Technical Service Bulletin Notification TSB #16-010

TECHNICAL SERVICE BULLETIN

TSB#: 16-010 Job Code: 9802289 Flat Rate: .4hr

Install 3amp fuse for LED awning lights

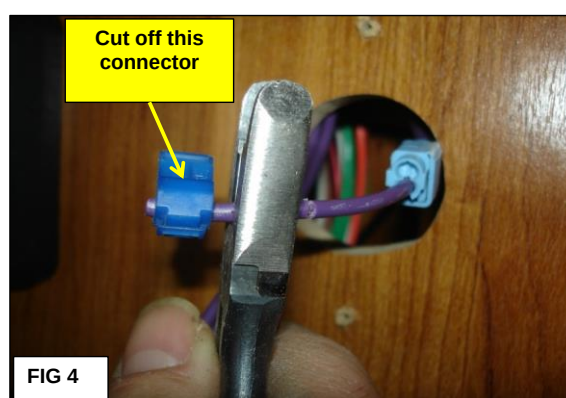
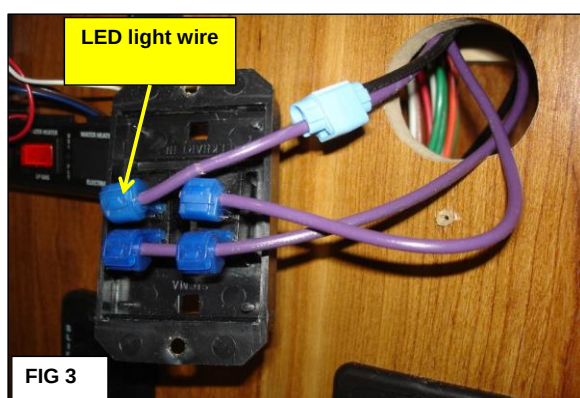
- 1 **Fig 1:** Locate the LED awning switch on the cabinet just inside the entrance door.
Remove the outer bezel by prying gently with a screwdriver.
Fig 2: Remove 2 screws holding the switch assembly to the panel.

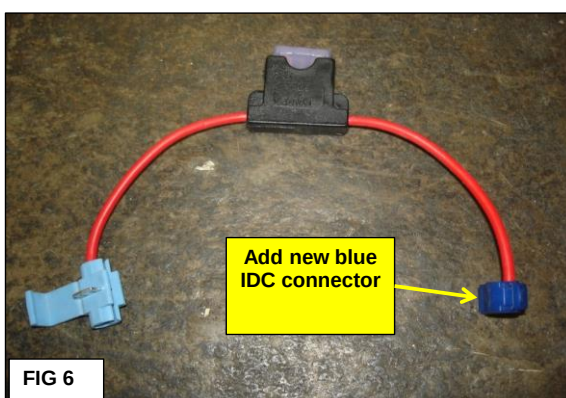
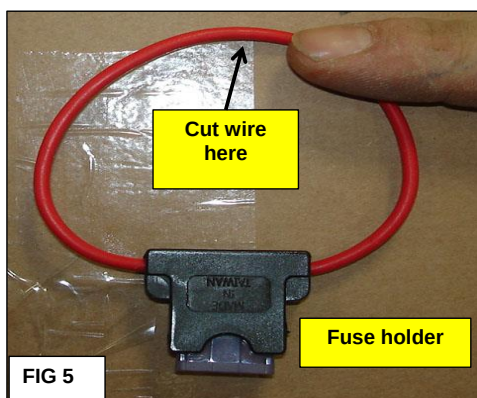
- 2 **Fig 3:** Pull the switch out of the panel and turn it over to locate the connection with the purple & black wires.
Fig 4: Unplug the wire from the switch, and cut off the blue connector on the end of the purple wire for the LED light.

FIG 7

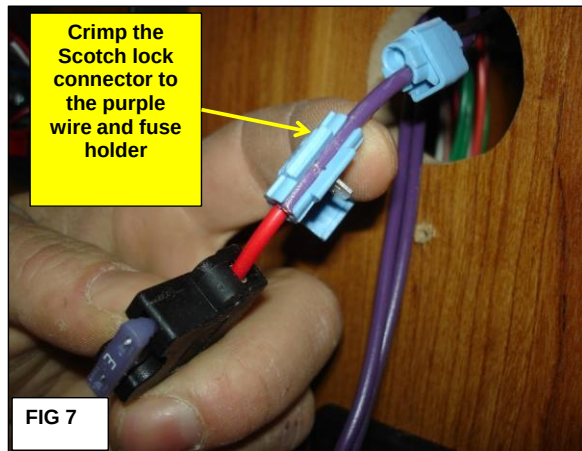
- 4 **Fig 7:** Crimp the Scotch lock connector on the red 14ga wire to the same purple wire you cut off the connector in step 2.(LED Light wire)
Fig 8: Place a 3 amp fuse in the fuseholder.

FIG 9

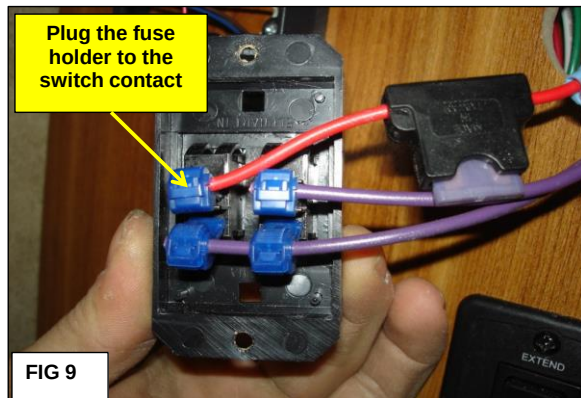
- 5 **Fig 9:** Plug the IDC connector for the fuseholder to the switch contact.
Fig 10: Push the wiring back into the hole, and replace the switch assembly. Secure the switch to the cabinet with the 2 screws removed earlier. Replace the switch bezel. Test the switch to turn on the LED awning lites.
